**MANDATORY
 SERVICE BULLETIN**

MSB-2007-001

- DATE:** August 20, 2007
- SUBJECT:** Installation, Fuel Drip Shield
- MODELS AFFECTED:** All 200HP Mooney M20 Series Aircraft with PFS-16201 exhaust systems installed (Exhaust System Serial Number 089 and below).
 All Diamond DA40 Aircraft with PFS-15102 exhaust systems installed (Exhaust System Serial Number 080 and below).

INSTALLATION:**SK07-001A
(M20J Only)**

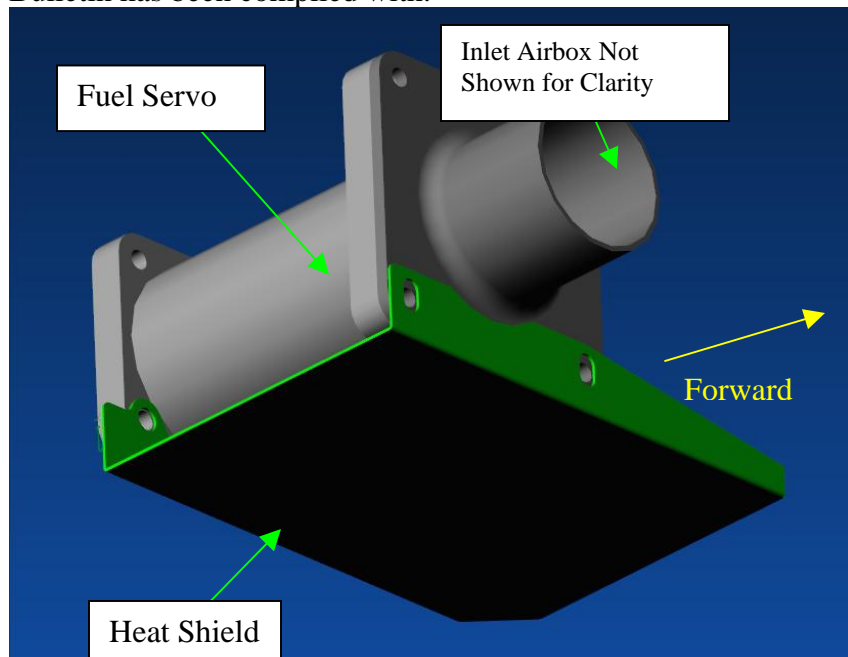
SK07-001A contains one heat shield (P/N 2002). This aluminum shield, to be attached to the fuel servo will serve as a “drip-pan” to catch any leaking fluids before they could contact an exhaust component. The shield is manufactured in a way that if it were to overflow, would do so safely onto the exhaust shroud, rather than the exhaust tubing.

Install heat shield to bottom of fuel servo using two forward and one aft attach bolts as shown. If equipped with a ram-air door, the ram-air actuating cable may need to be rerouted slightly for clearance. Torque and Safety in accordance with the latest approved revision of the applicable Mooney Service Manual. Make an entry in the airframe logbook stating that this Service Bulletin has been complied with.

SK07-001B
(All Others)

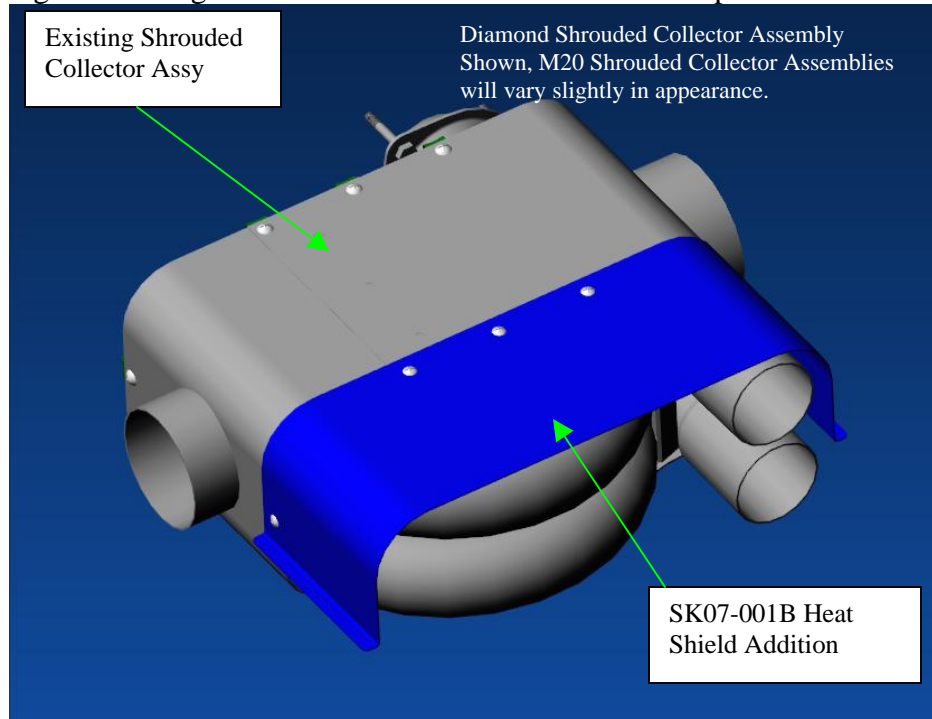
SK07-001B contains one heat shield (P/N 2003) five screws and five Tinnerman clips for installation. This stainless steel shield, to be attached to the collector assembly would effectively extend the existing heat shroud to cover the top and forward portions of the collector tubes. Any fuel leaks would hit this shroud rather than the exhaust tubing.

To be installed when re-installing the cabin heat shroud during the next 100hr or annual inspection (see Instructions for Continued Airworthiness for the installed exhaust system). Install heat shield using three top fastener locations and forward and rear fastener locations as shown (note that the collector assembly may vary slightly in appearance). Make an entry in the airframe logbook stating that this Service Bulletin has been complied with.
